# **ADDENDUM** | No. 1

**PROJECT** Lake Vermillion Lift Station and Drainfield Improvements

**ISSUE DATE** | 8/20/2024

# **INSTALLS OVERALL SITE**

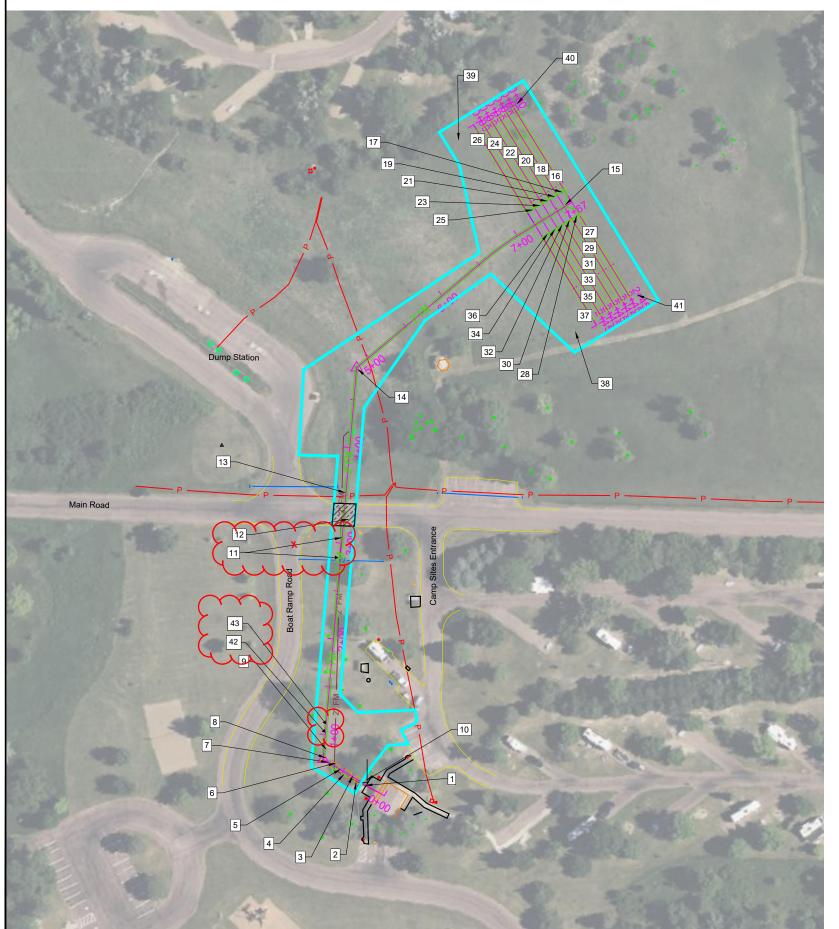
# 4) Drawing Sheet C-201 - Installs Overall Site

In the install list, add the following items:

Add the following call outs in the plan view:

Adjust leader of call out 11 in the plan view to further south to the shown estimated water line location.

42. FURNISH AND INSTALL:

1 EA - VERIFY UTILITY

43. FURNISH AND INSTALL:

1 EA - VERIFY UTILITY

42. FURNISH AND INSTALL:

1 EA - VERIFY UTILITY

43. FURNISH AND INSTALL:

1 EA - VERIFY UTILITY
